RE:	AUTOMATIC TRANSMISSION BW 35	PRODUCT P GROUP 44 NO. 1
DATE	October 25, 1972

Valve spindle for centrifugal governor

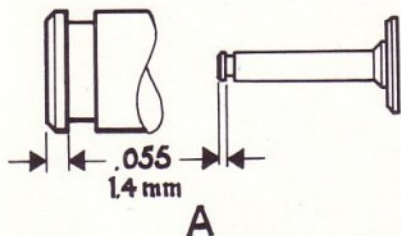
It has happened on a number of occasions that the valve spindle for the new centrifugal governor, see WB P - 44 - 26, has been too long. With unfavourable tolerances, the spindle can catch in the inside of the rear housing and disturb the function of the governor.

When fitting a new governor, or when checking an installed governor, check also the measurement according to the Figs. below. If the spindle is too long (B), grind it off to the correct length (A).

A. Correct spindle

B. Incorrect spindle
